AIR - HP COMPRESSOR VARIABLE STATOR VANE ACTUATOR (VSVA) - INTRODUCTION OF RETURN PORT,  
NON RETURN VALVE - CATEGORY CODE 4 - MOD.ENG-75-0020

V2500-ENG-75-0020

1685-75-002  
ENGINE COMPRESSOR CONTROL-VARIABLE  
STATOR VANE ACTUATOR. INTRODUCTION OF  
RETURN PORT, NON-RETURN VALVE

Location of VSVA and LP return fuel tube  
Fig.1

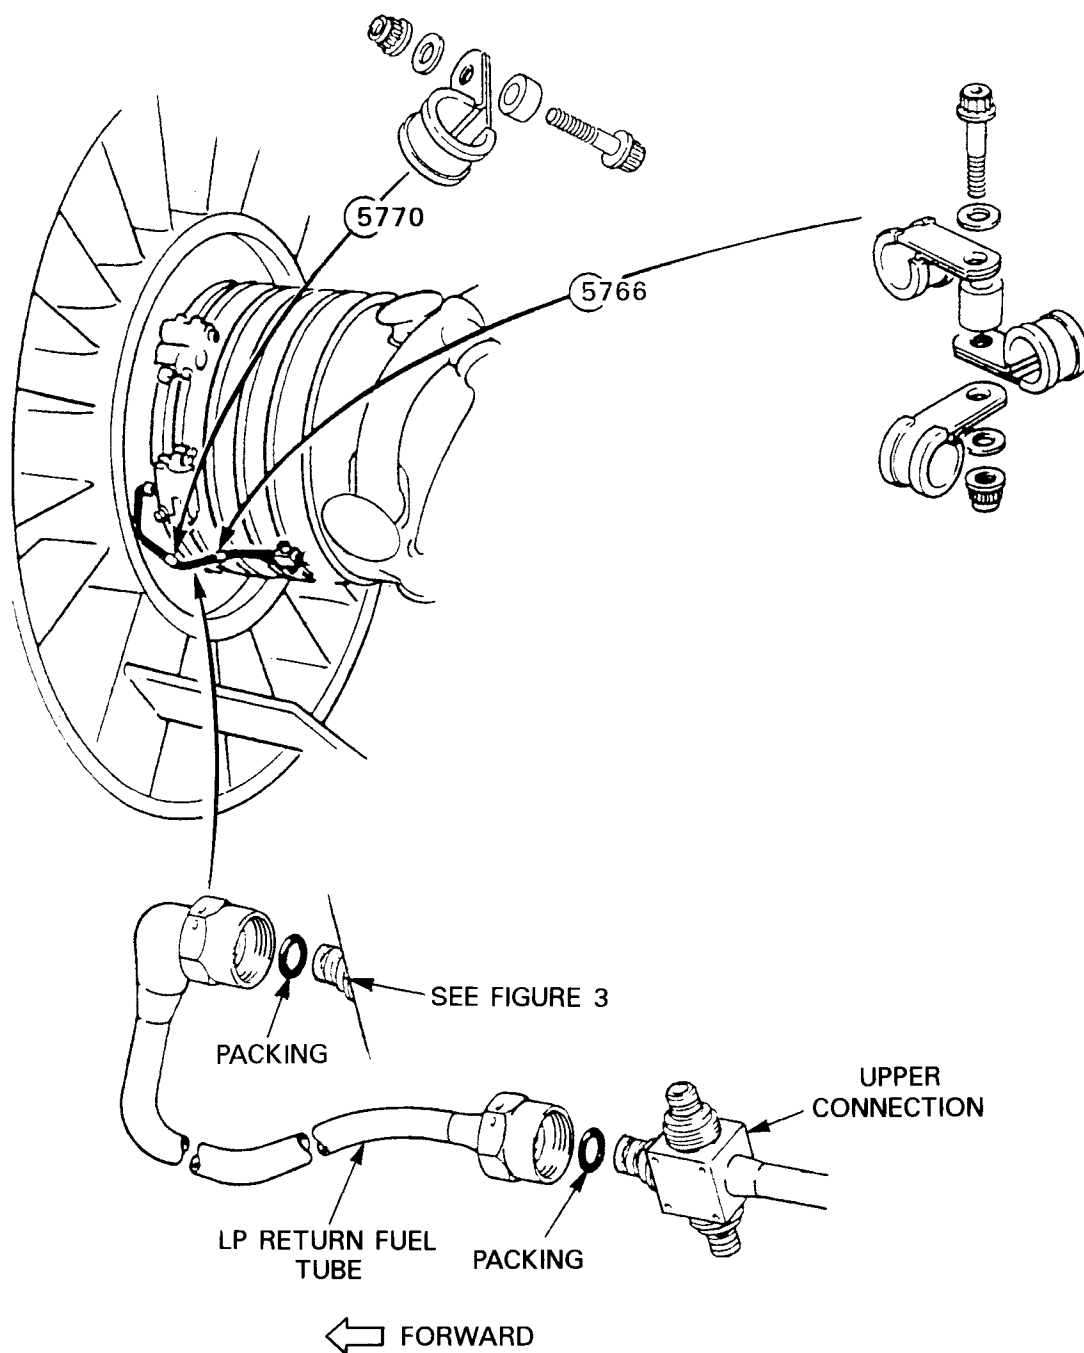
- (1) Cut and discard the wire and disconnect the LP return fuel tube at the VSVA. Discard the packing. Refer to Figures 2 and 3.
- (2) Cut and discard the wire and disconnect the LP return fuel tube at the upper connection. Discard the packing. Refer to Figure 2.
- (3) Slacken clipping points 5766 and 5770. Refer to Figure 2.
- (4) Position the LP return fuel tube to allow access to the VSVA LP return union.

Assembly of the Non-return Valve  
Figure 1

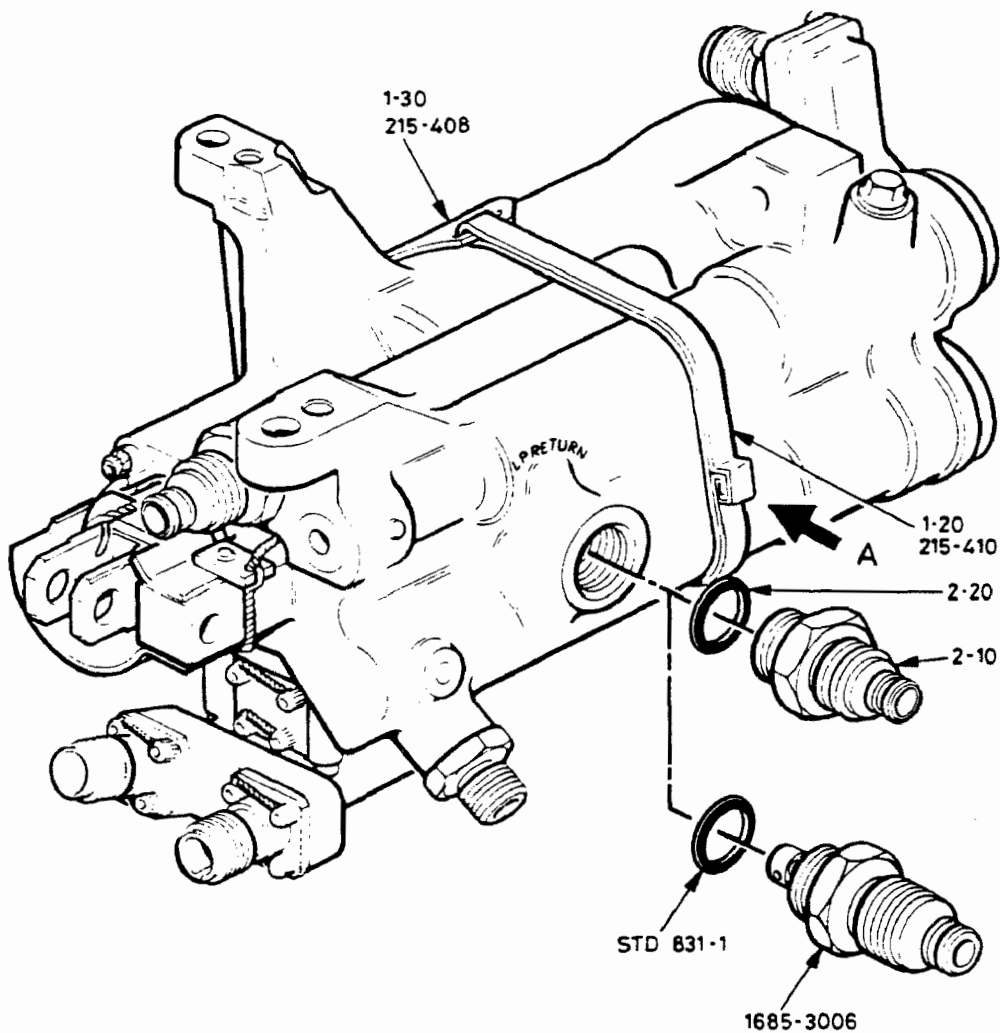
### A. Install the Non-return Valve (Figure 1).

(1) Unscrew and remove the union adaptor (2-10) from the connection marked 'L.P. RETURN'; remove the sealing ring (2-20).

(2) Fit the new toroidal sealing ring STD831-1 (supplied with the Mod. kit), to the non-return valve assy. 1685-3006.

- (3) Assemble the non-return valve assy. 1685-3006 to the unit connection marked 'L.P. RETURN'; torque tighten the non-return valve assy. to 300 lbf.in. (34 Nm).
- (4) Release the strap (1-20) which secures the data plate (1-30), remove the strap and the data plate; keep the data plate but discard the strap.

- (1) Bend the new data plate 215-408 to the shape of the VSVA body; use the body as a former.
- (2) Attach the data plate to the VSVA; use the new strap 215-410. Loop the strap through both ends of the data plate and bend the ends together as shown.
- (3) Make sure that the data plate is secure on the VSVA.
